Project	<b>IEEE 802.16 Broadband Wireless Access Working Group</b> < <a href="http://ieee802.org/16">http://ieee802.org/16</a> >	
Title	Problem in Interleaver and Permutation Combination in OFDMA	
Date Submitted	<b>2005-07-13</b>	
Source(s)	Ayelet Doron Yuval Lomnitz Uri Perlmutter Eyal Bick Dov Andelman Assi Jakoby Alexei Davydov Weisman Tzahi Intel.	<a href="mailto:Ayelet.Doron@intel.com">Ayelet.Doron@intel.com</a> <a href="mailto:Yuval.Lomnitz@intel.com">Yuval.Lomnitz@intel.com</a> <a href="mailto:Uri.PerlMutter@intel.com">Uri.PerlMutter@intel.com</a> <a href="mailto:Eyal.Bick@intel.com">Eyal.Bick@intel.com</a> <a href="mailto:Dov.Andelman@intel.com">Dov.Andelman@intel.com</a> <a href="mailto:Assi.Jakoby@intel.com">Assi.Jakoby@intel.com</a> <a href="mailto:Alexei.Davydov@intel.com">Alexei.Davydov@intel.com</a> <a href="mailto:Tzahi.Weisman@intel.com">Tzahi.Weisman@intel.com</a>
Re:	IEEE P802.16-2004/Cor1-D3

# Problem in Interleaver and Permutation Combination in OFDMA

**Figure 1: Worst case scenario of permutation-interleaver combination**

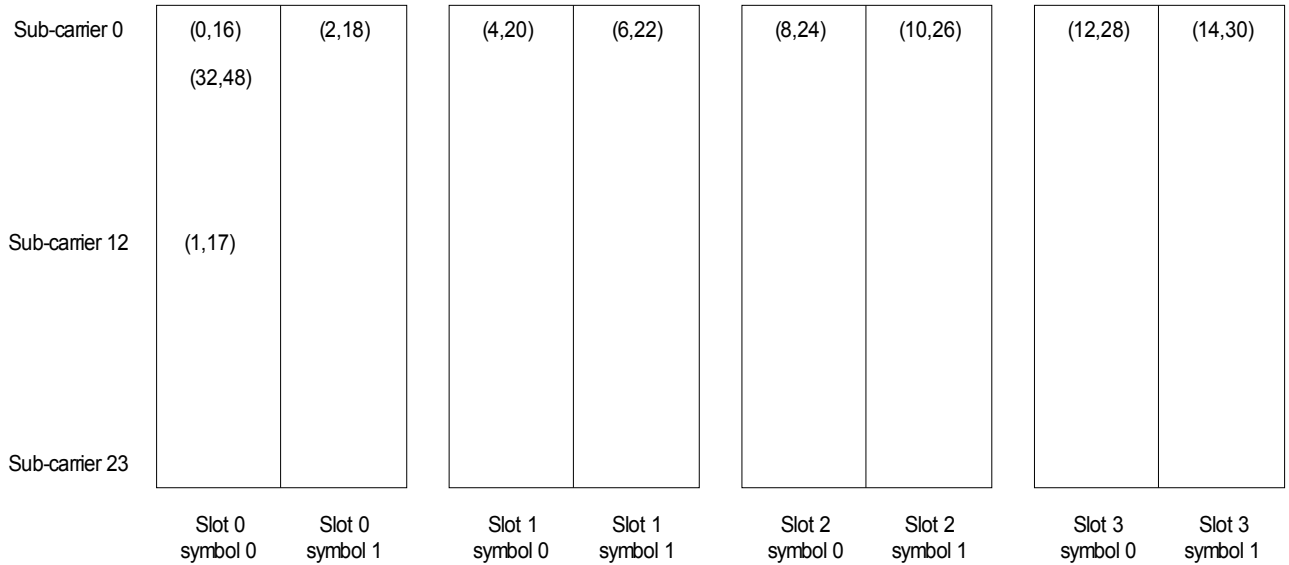
For an interleaver with dimension  $d$ , a pair of adjacent coded bits before the interleaver is separated after the interleaver by distance  $N_{cbps}/d$  bits. If a FEC block spans more than one slot duration, then several bits from the same FEC block are transmitted on each sub-carrier. These bits are distributed in the FEC block periodically, where the period equals the number of bits in a single symbol divided by the distance.

With the current interleaver dimension  $d = 16$ , for a worst case scenario (DL PUSC, burst allocation of 1 sub-channel, 4 slots in a FEC block, QPSK constellation) this period can be as small as 2 bits!! This example is depicted in Figure 1 where the numbers in brackets are the indices of the coded bits before the interleaver.

Figure 2: Example of correlation in slot and FEC block

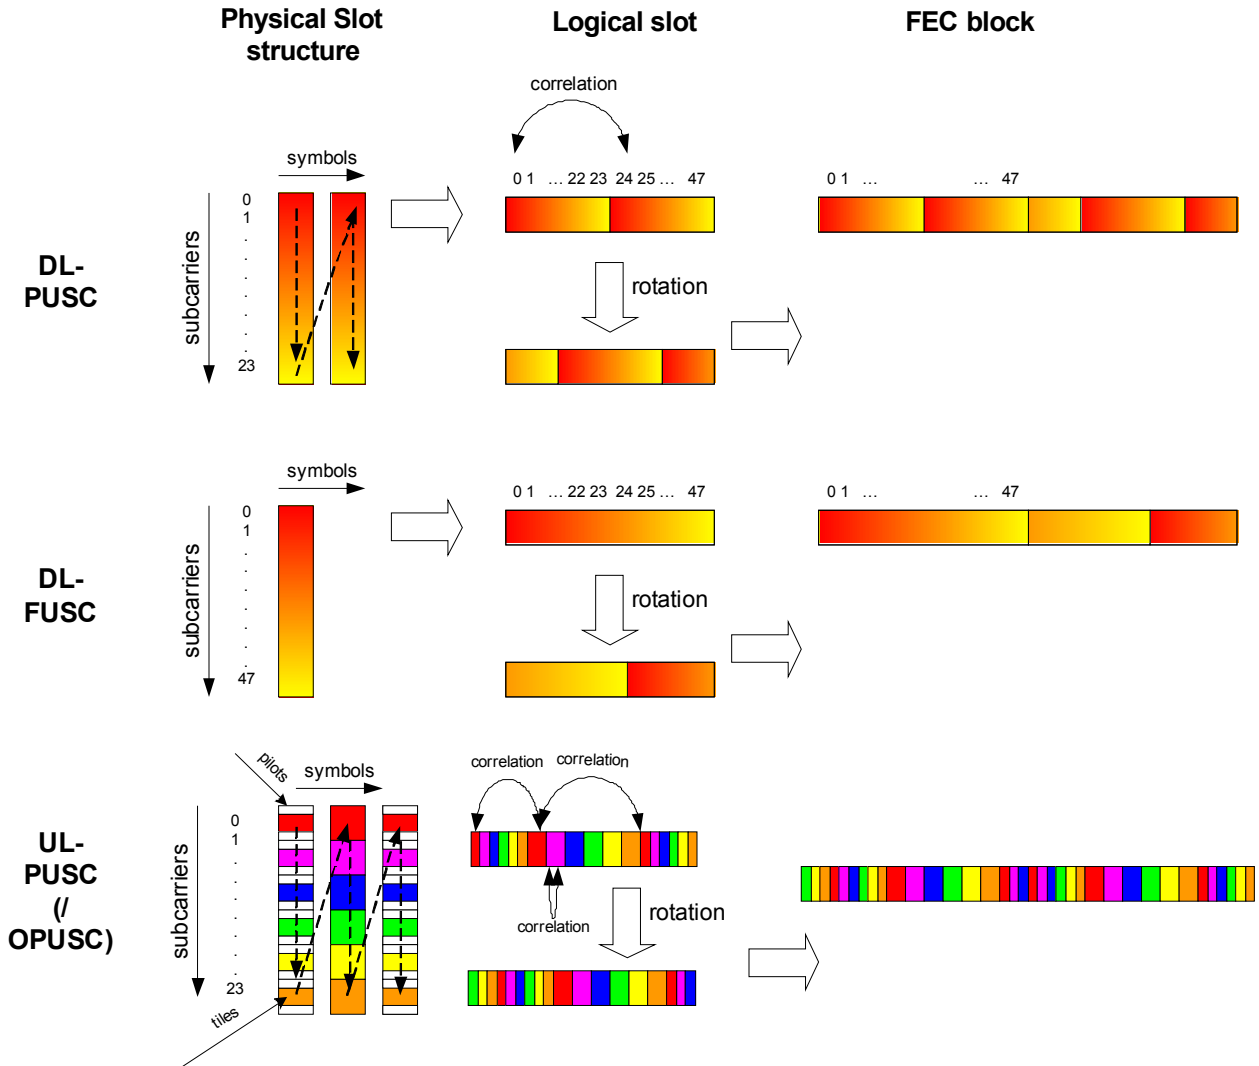
The reason for this is that the order of subcarriers passed to the de-interleaver (in the receive side) is not a linear frequency-domain order (which the interleaver was designed for), but an arbitrary order. This order depends on the permutation, on the way the 48 logical subcarriers are mapped to physical subcarriers, on the in-slot rotation between subchannels, and on the way the slots are aggregated. The following figure shows the correlation structure in a FEC block on which the de-interleaver works (and of which the interleaver is unaware):

The seemingly "random" structures of correlations in the FEC block are processed by the de-interleaver and create another "seemingly random" correlation structure at the input to the decoder. However, since these sequences are repetitive and not random, there are unfortunate choices of FEC block size for each permutation that create high correlations and reduce the performance significantly.
